Manual Supplement

Manual Title:	753/754 Users	Supplement Issue:	**7**
Print Date:	July 2011	Issue Date:	2/22
Revision/Date:	1, 8/12	Page Count:	7

FLUKE ®

Figure 1. Standard Equipment

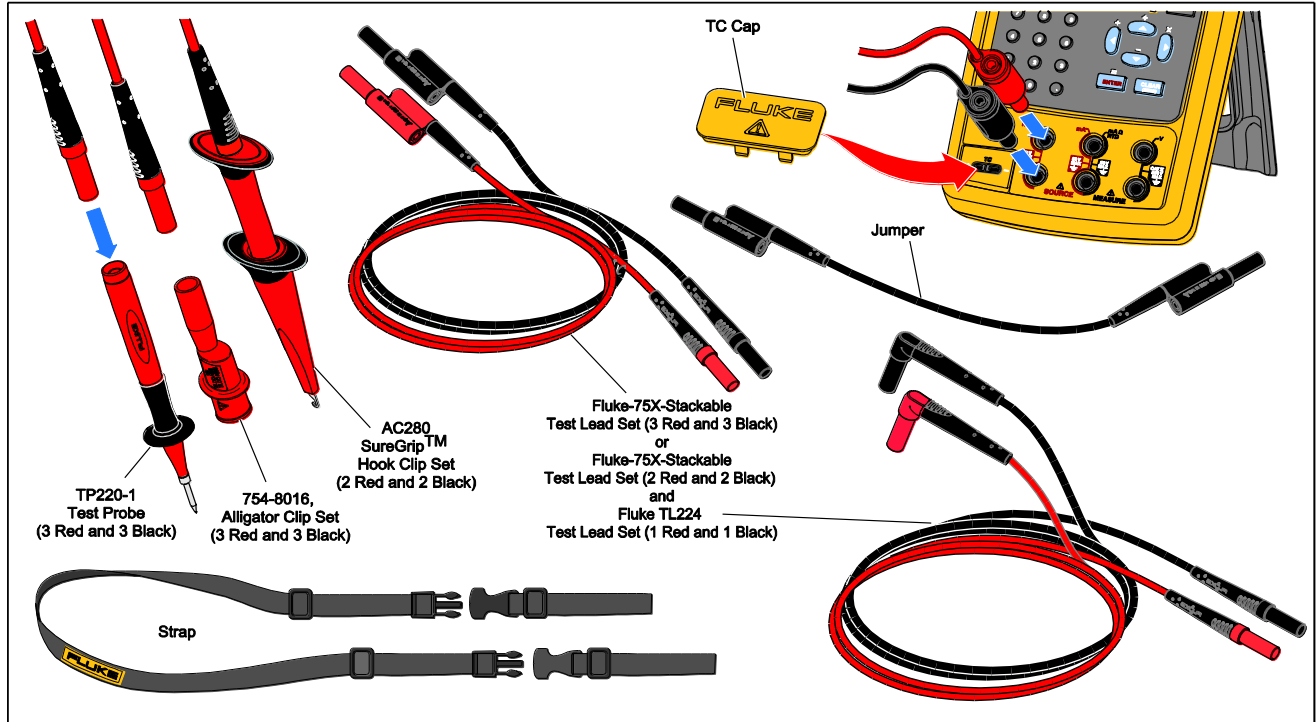
On page 7, replace Figure 1 with:

- Three sets of 75X industrial test leads with stackable ends or two sets of 75X industrial test leads with stackable ends and one set of TL224 industrial test leads.
